**PLANNING CLEARANCE**  
 (Single Family Residential and Accessory Structures)  
Community Development Department

BLDG ADDRESS 324 Quail Drive SQ. FT. OF PROPOSED BLDGS/ADDITION 3400

(<sup>1</sup>) TELEPHONE 201-3823 DESCRIPTION OF WORK & INTENDED USE New home & garage

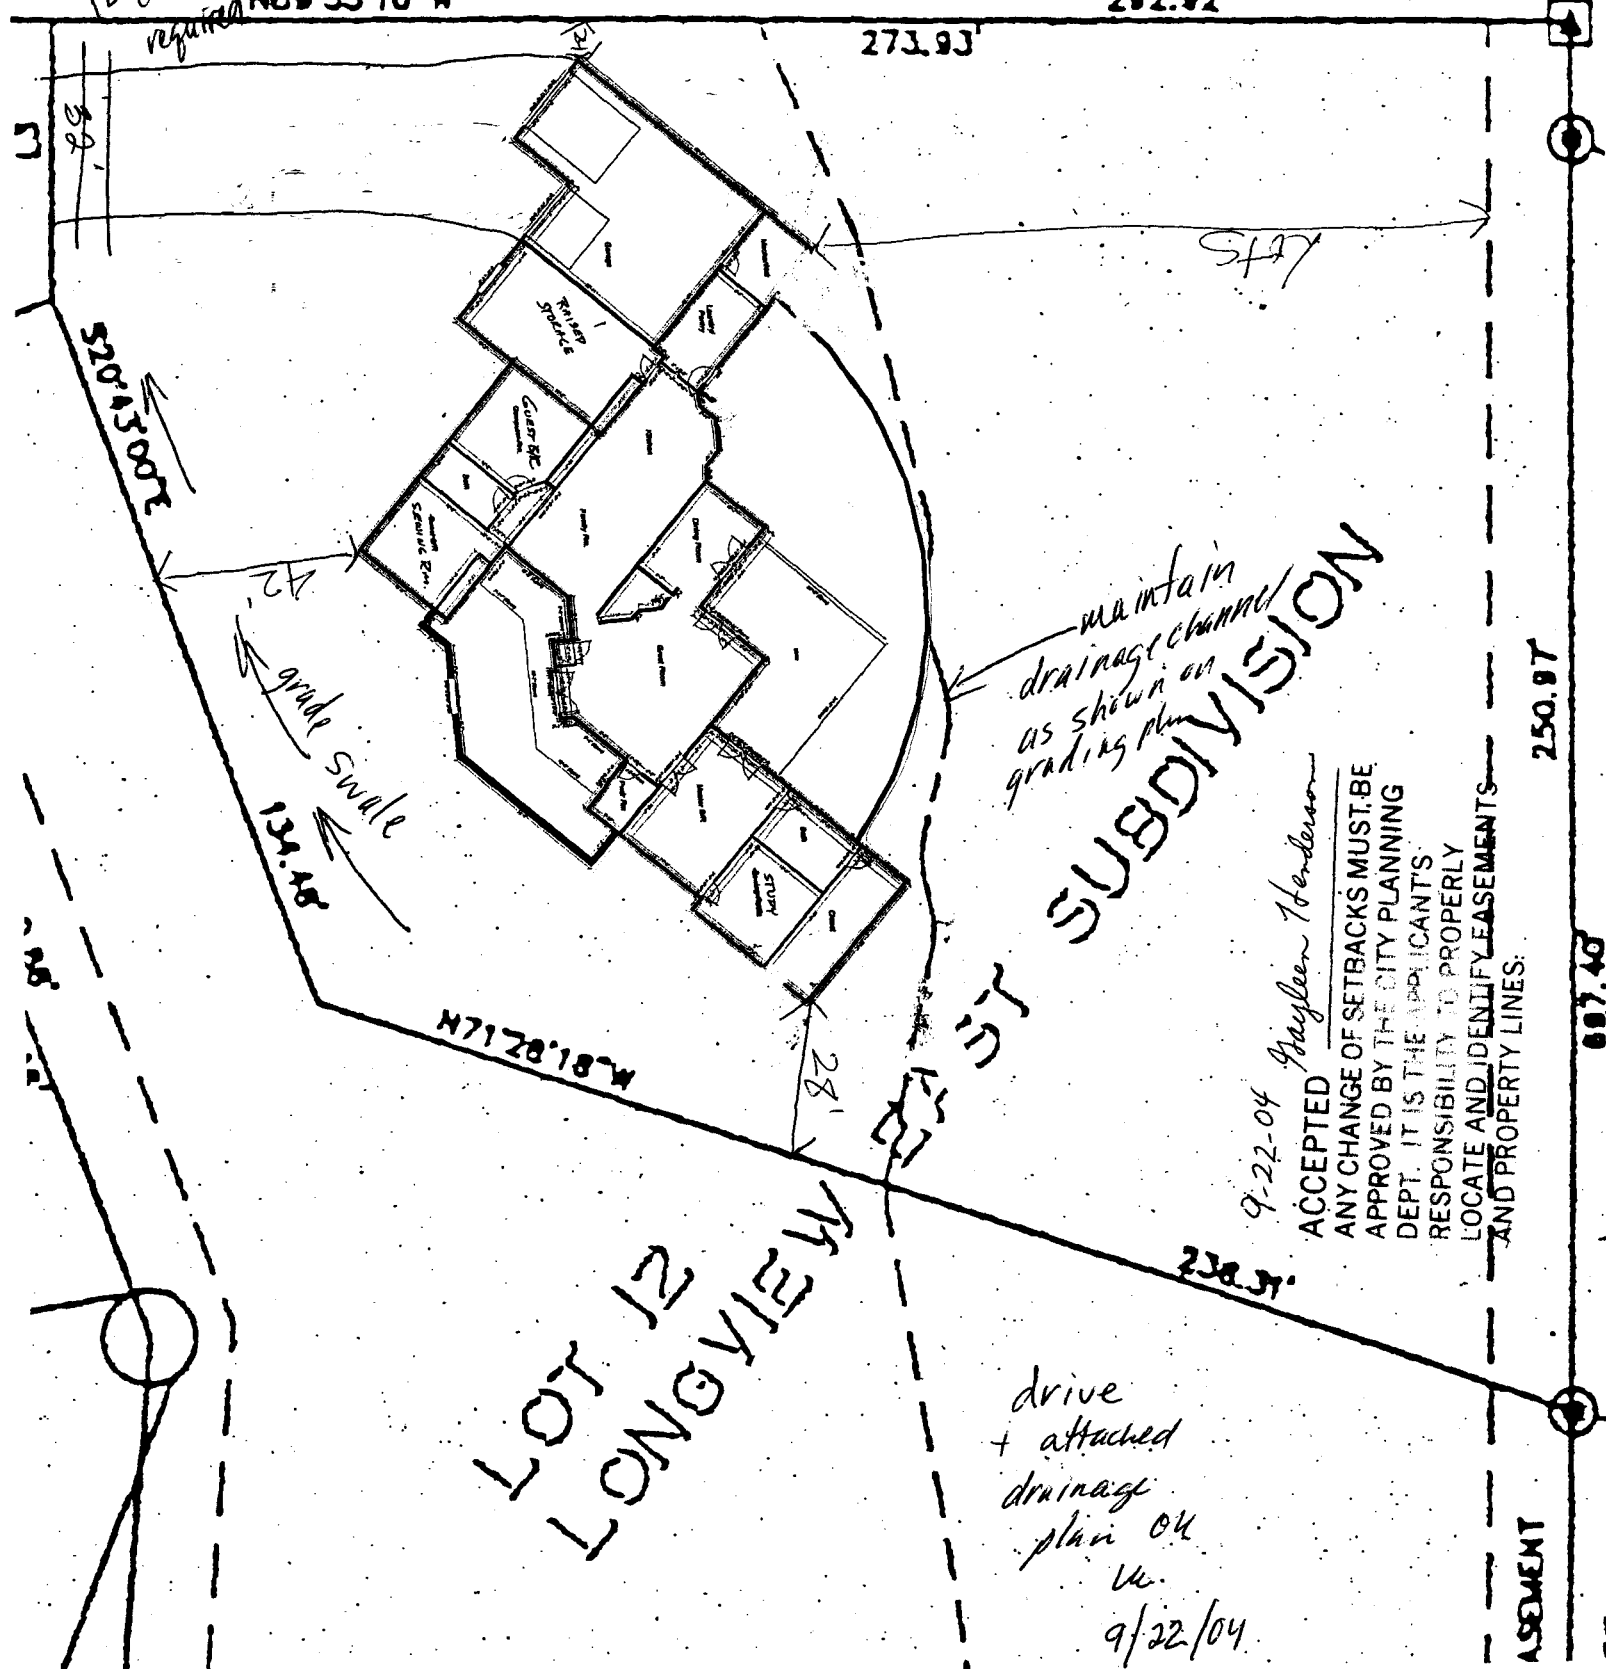
12" culvert  
required

maintain  
drainage channel  
as shown on  
grading plan

drive  
+ attached  
drainage  
plan 04  
ll.  
9/22/04

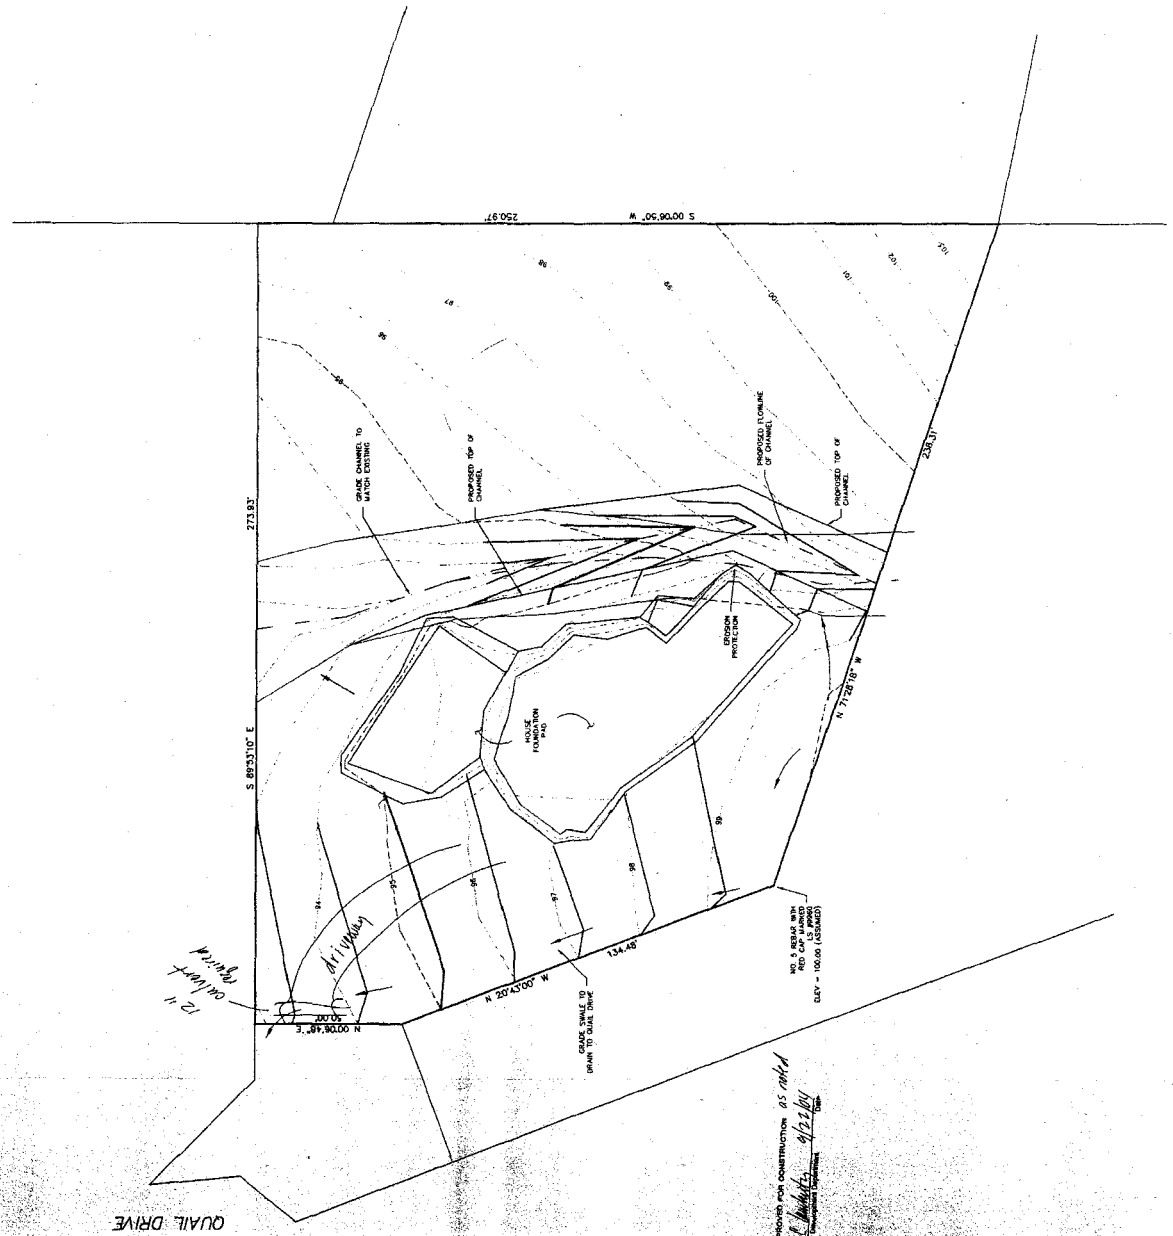
*12 ft  
collected  
drain*

APPROVED FOR CONSTRUCTION as noted  
*Dale Cole*  
 9/22/04
